Dean Moor Solar Farm

Environmental Statement: Appendix 7.8 – Arboricultural Impact Assessment

Deadline: 2

Revision: ~~21~~

Legend

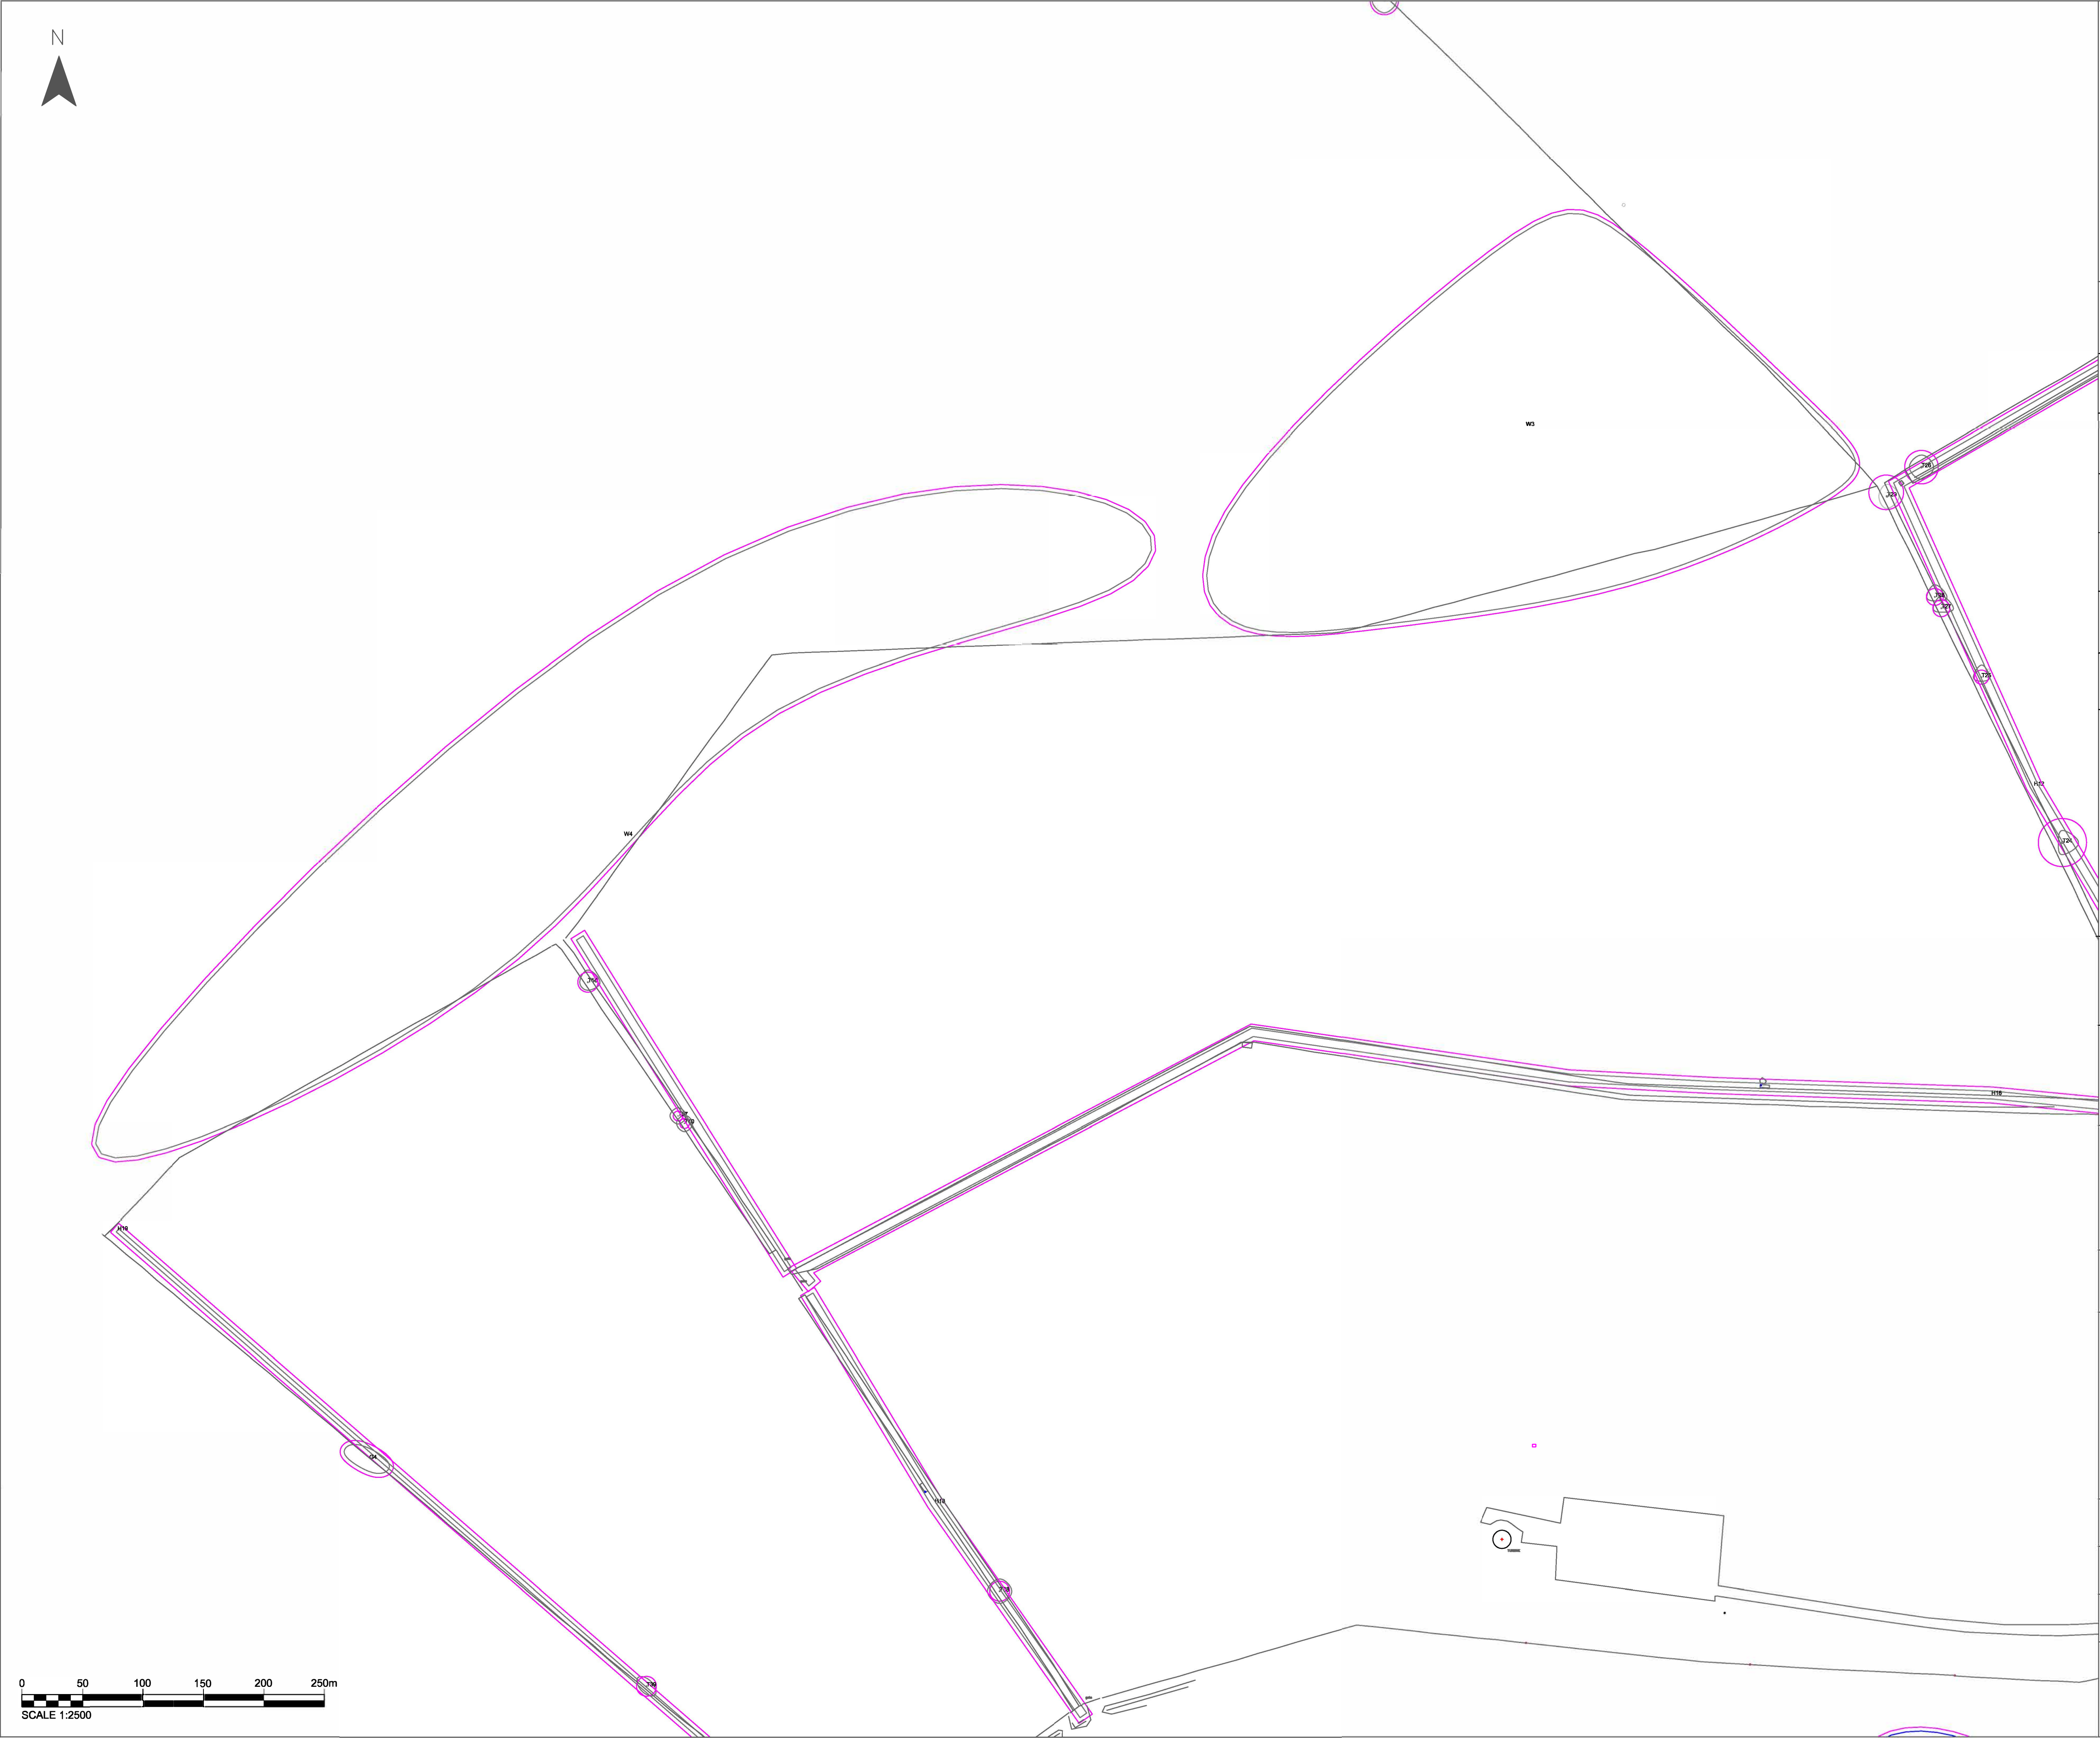
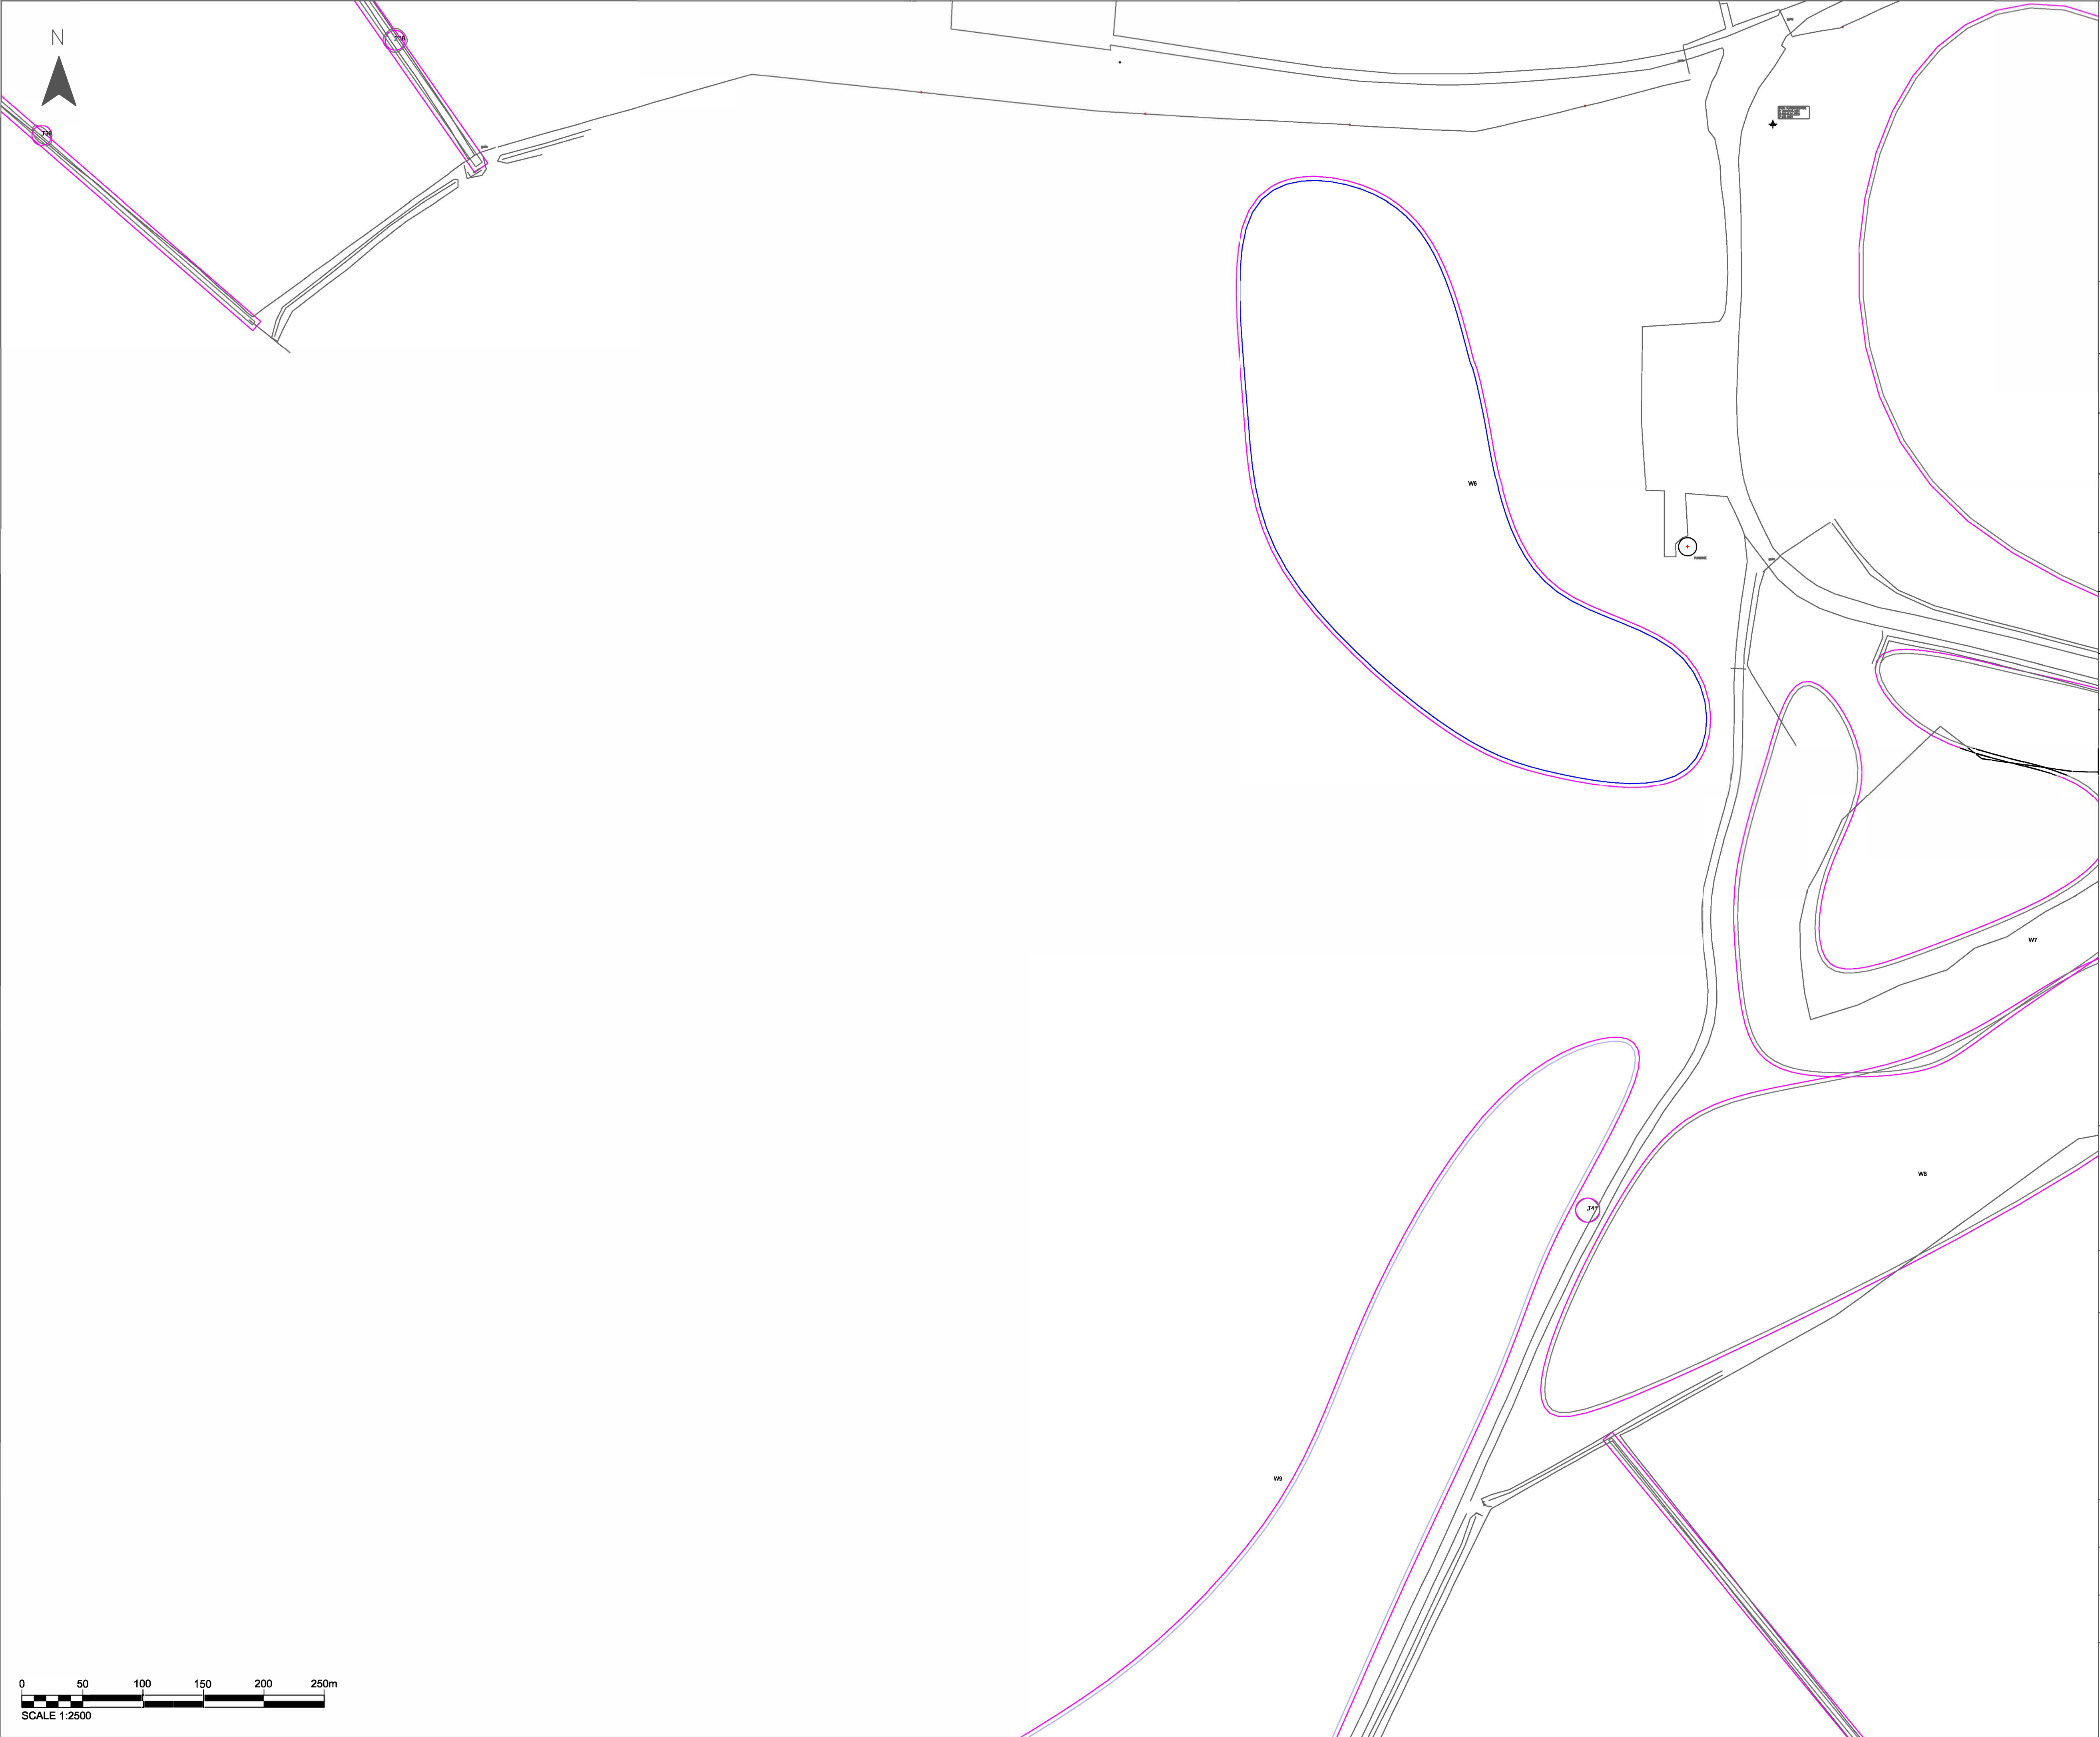
Revision	Reason
Change of the plan title in the TCP from 'Location Plan' to 'Tree Constraints Plan'	To make it clear that the plan is displaying the TCP. As the Location Plan is a different figure within the ES.
A renumbering of the sheets included in the TCP. Changing the order from 0-22 to 1-23.	To enable the first sheet within the TCP is numbered 1 rather than 0.
Change of the plan title in the TPP from 'Location Plan' to 'Tree Protection Plan'	To make it clear that the plan is displaying the TPP. As the Location Plan is a different figure within the ES.
A renumbering of the sheets included in the TPP. Changing the order from 0-22 to 1-23.	To enable the first sheet within the TPP is numbered 1 rather than 0.
